**MARCH 20, 2012 ZONING HEARING
“OTHER BUSINESS”
COMMISSION DISTRICT 1**

ITEM # 2

To consider approving a site plan for Governors Towne Square, LLC regarding rezoning application Z-5 (Governors Towne Square, LLC) of 2010, for property located in Land Lot 40 of the 20th District, located on the southerly side of Cedarcrest Road, between Acworth Dallas Road and U.S. Highway 41.

State specifically the need or reason(s) for Other Business:
APPROVE FINAL SITE PLAN OF McDONALD'S RESTAURANT ON PART OF THIS PARCEL.

March 20, 2012
Other Business Item 02
Exhibit B

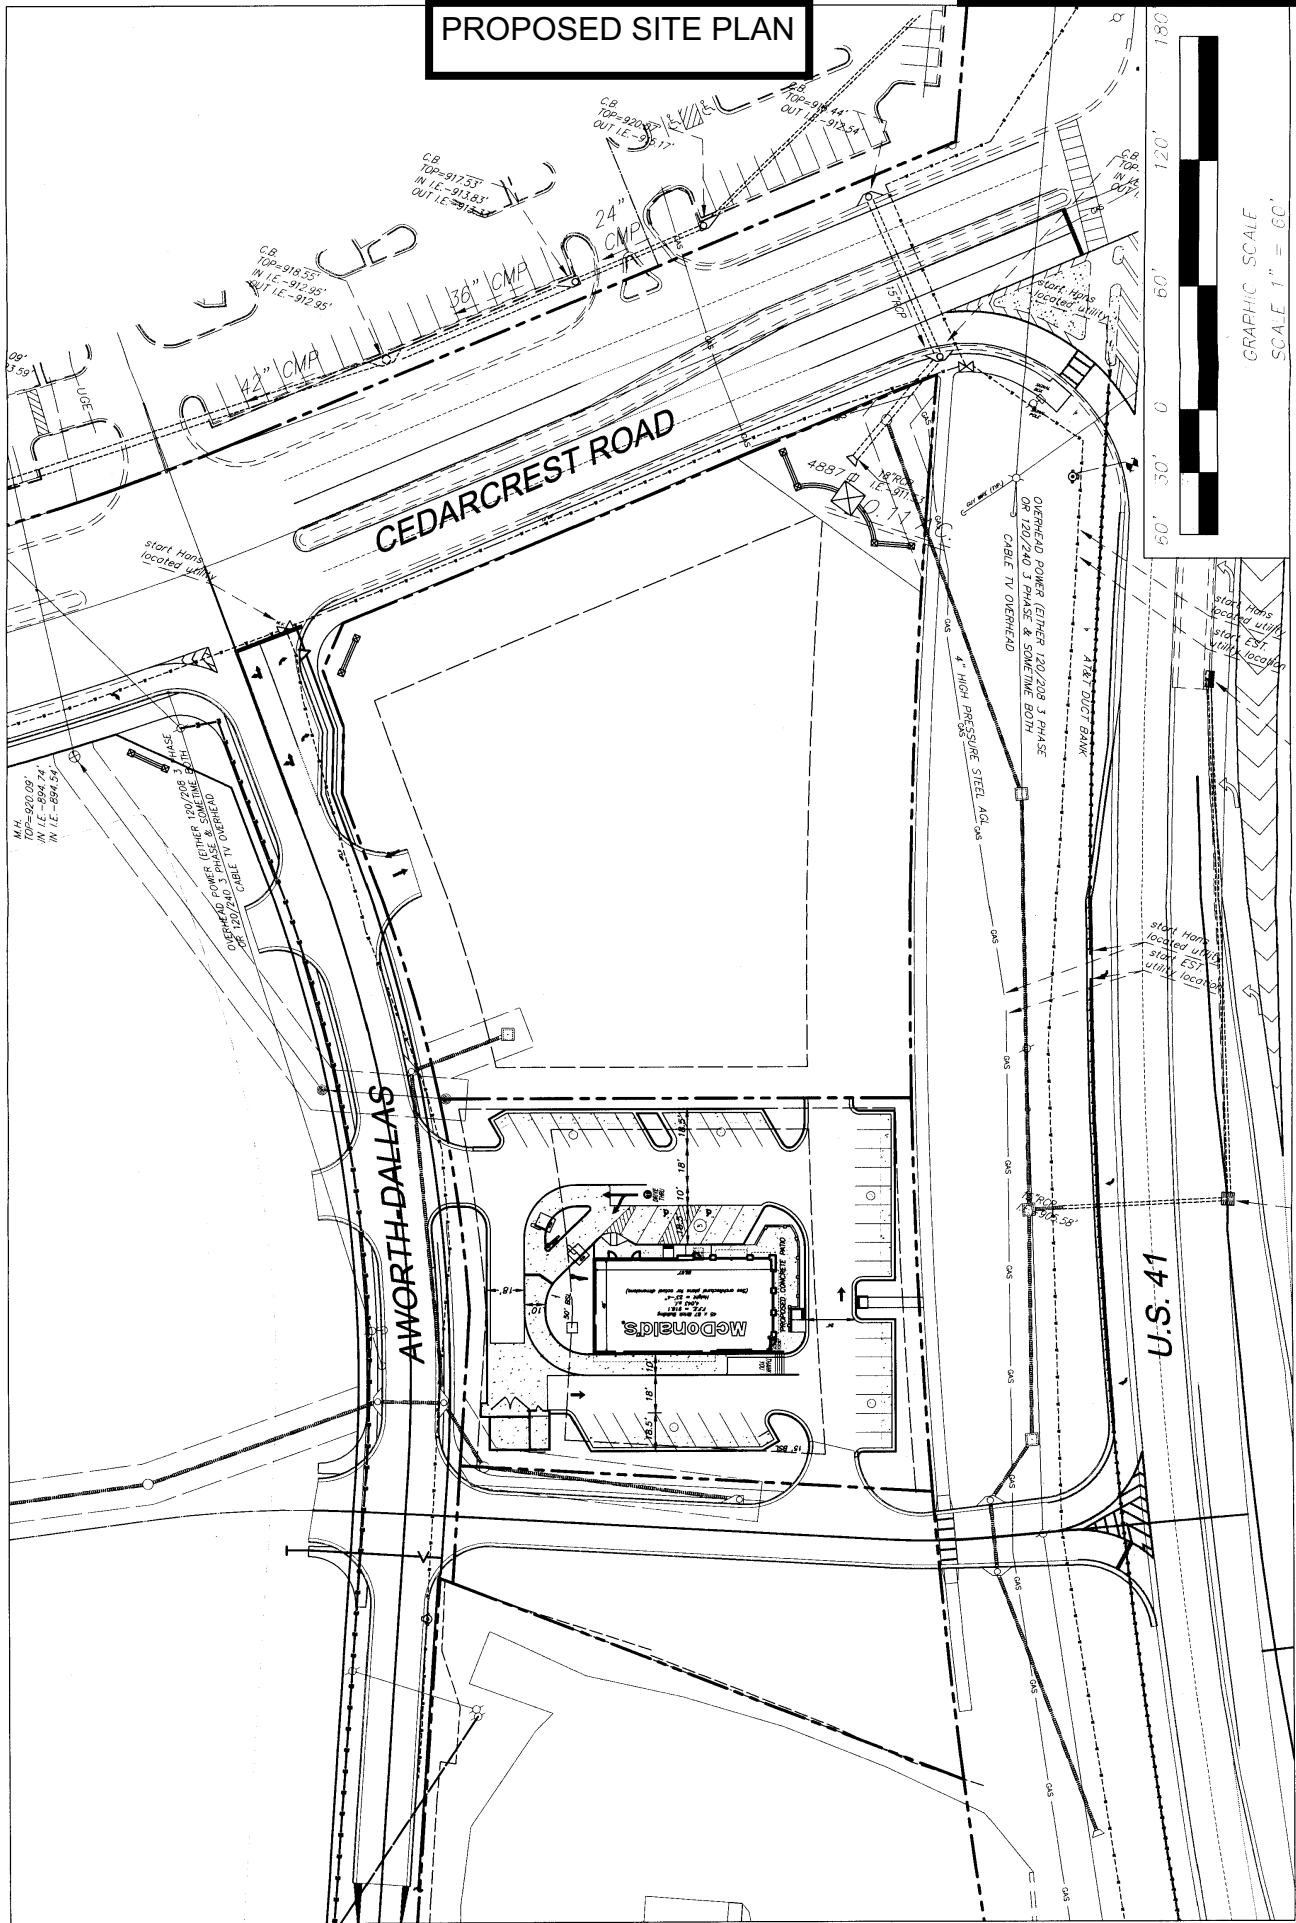
Cobb DOT: “Recommend a two way left turn lane along the frontage on Acworth Dallas Road when the average daily traffic on Acworth Dallas Road meets or exceeds 5000 vehicles per day.”

Min. Pk. 400 Pctition No. Z-5
 Doc. Type Site Plan
 Meeting Date 4/20/10

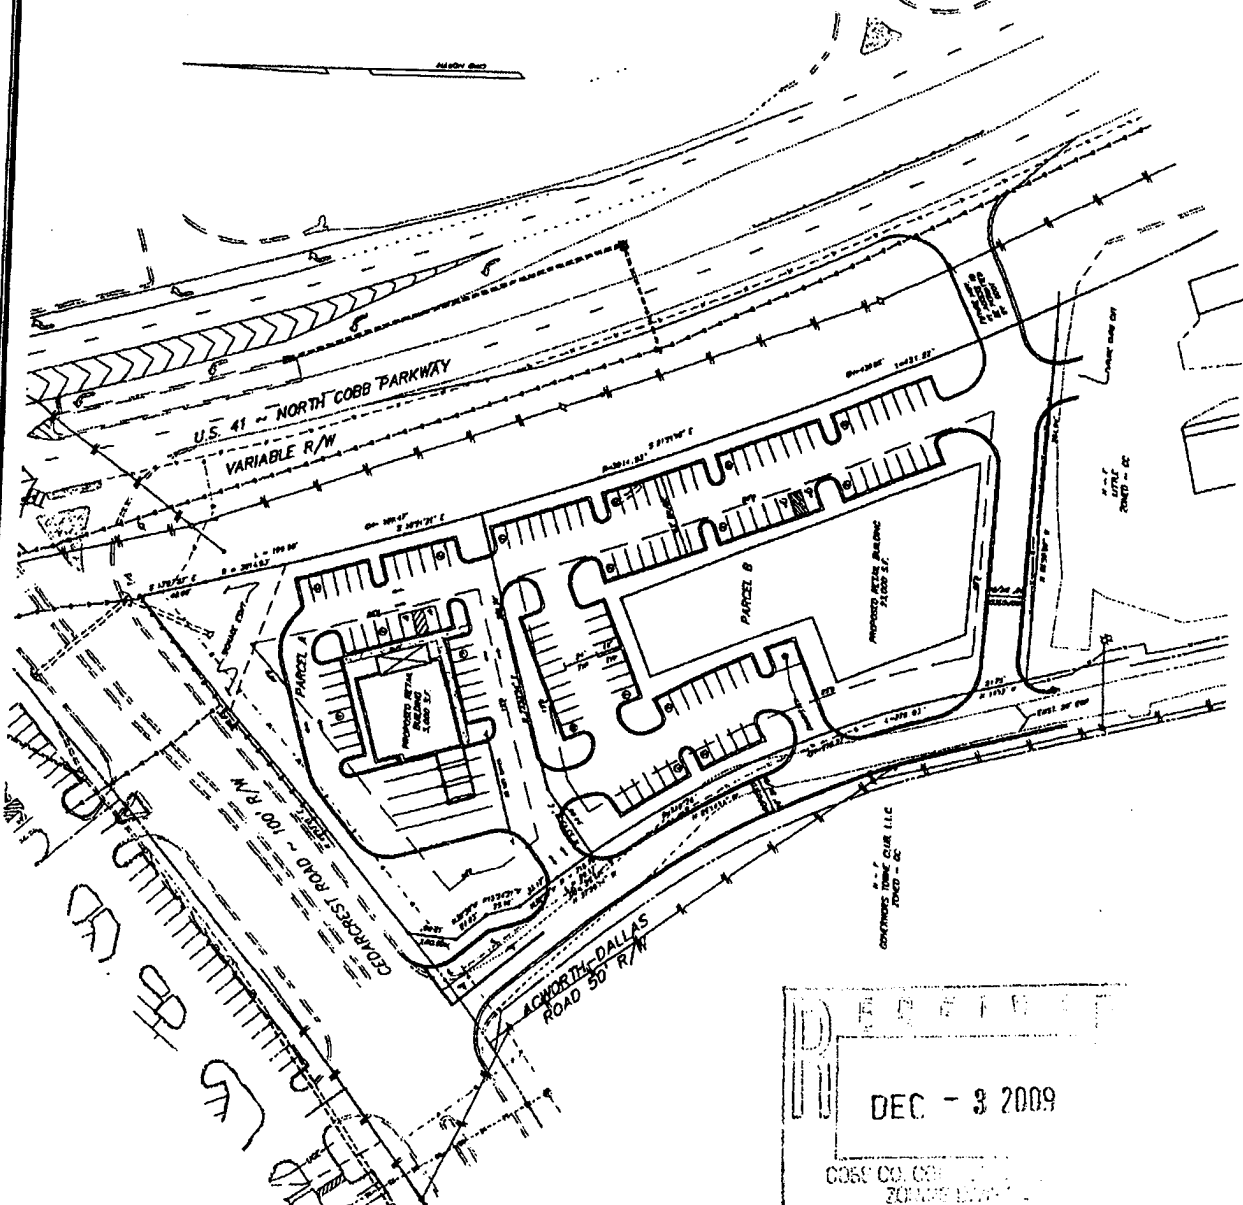
As necessitated by this development for egress from Cobb Parkway, a deceleration lane will be required at the proposed access drive.

As necessitated by this development for egress from Cedarcrest Road, a deceleration lane will be required for Acworth Dallas Road.

Install curb and gutter along both sides of Acworth Dallas Road.

Install sidewalk along the east side of Acworth Dallas Road frontage.

Acworth Dallas Road is not located as shown on the proposed plan. A right-of-way swap needs to be executed for the relocated Acworth Dallas Road.
